2J Antennas

WillowBee SI328100009 - Coil Antenna
Dual-Band 868/915 Matching Validation

November 2023

MATCHING NETWORK FOR COIL ANTENNA

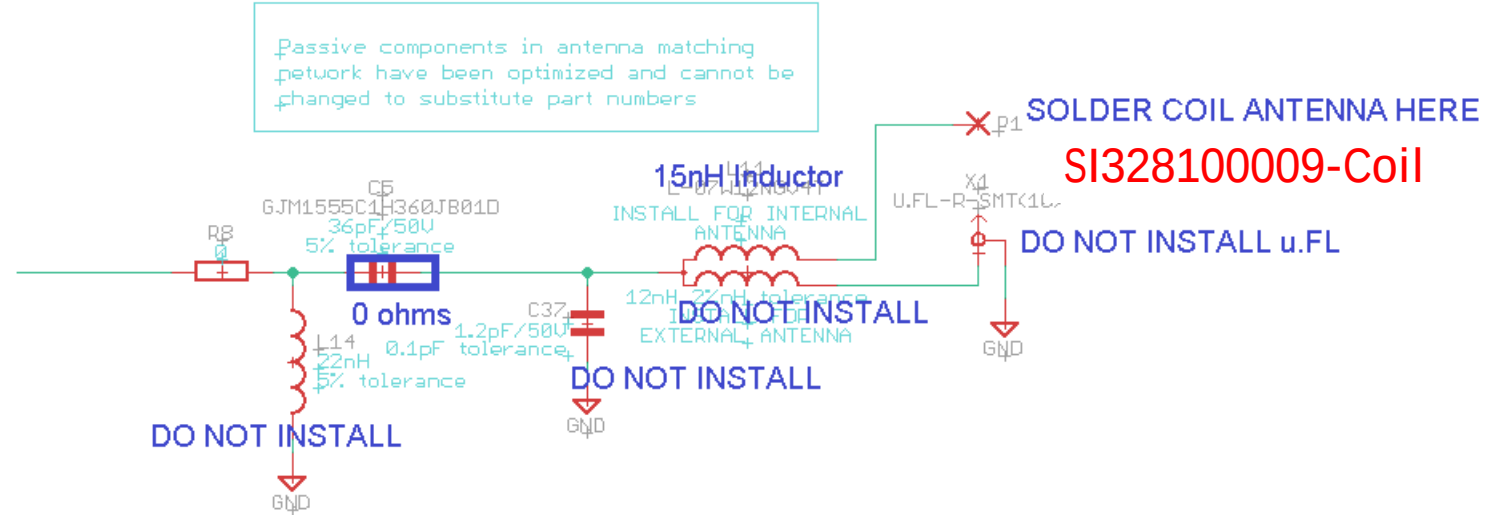
- Thru-Hole Monopole SI328100009-Coil Antenna from 2J did not need any change on previous tuning.
- Only one series inductor is enough to achieve tuning and matching on antenna TX Line.
- With current Design, presented solution can be implemented with no additional changes on matching circuit, keeping great performance for such a small form factor.
- No change was noted on the location of inductor, can be placed anywhere on Tx Line, it will not affect matching or OTA performance.
- Please keep integration guidelines from previous report.
- Please remember not populating SMD component to UFL Connector, since that will affect antenna tuning.
